UNITED STATES
NUCLEAR REGULATORY COMMISSION
WASHINGTON, D. C. 20555

SUBJECT: REVIEW OF THE U.S. DEPARTMENT OF ENERGY (DOE) STUDY
PLAN ON "CHARACTERIZATION OF THE YUCCA MOUNTAIN SITE
UNSATURATED ZONE (REVISION 2)" (8.3.1.2.2.4)

STUDY PLAN 8.3.1.2.2.4

CHARACTERIZATION OF THE YUCCA MOUNTAIN SITE UNSATURATED ZONE

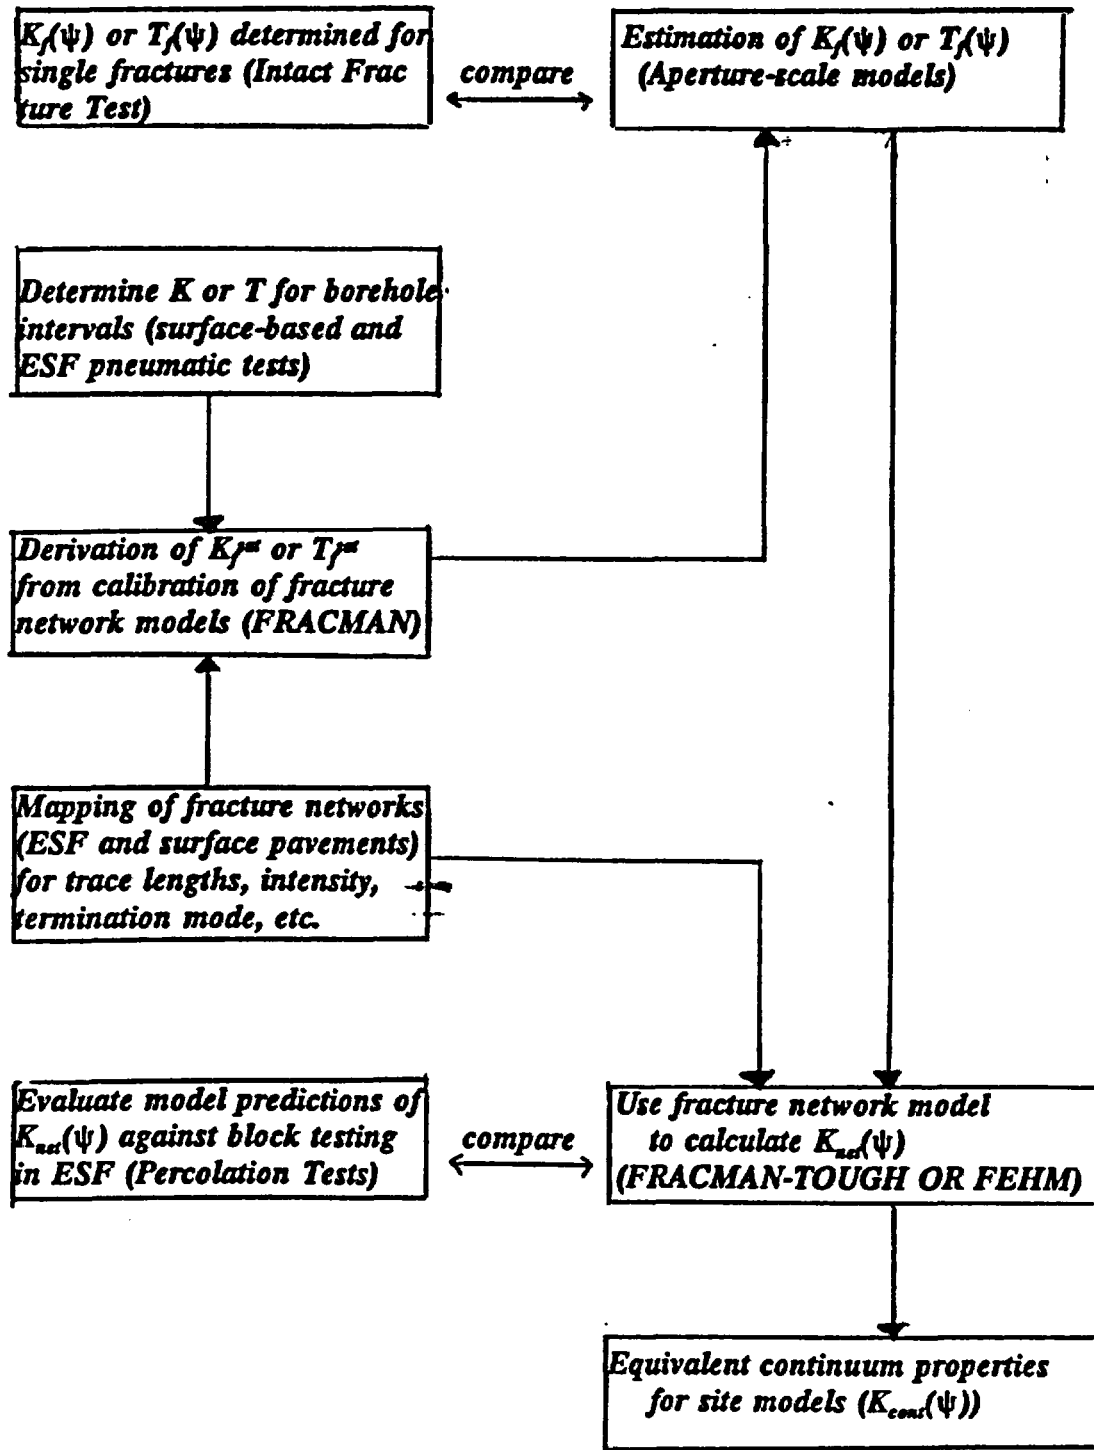
NRC QUESTION 2:

A logic diagram describing the studies that contribute fracture information and how that information is synthesized is contained in an accompanying figure.
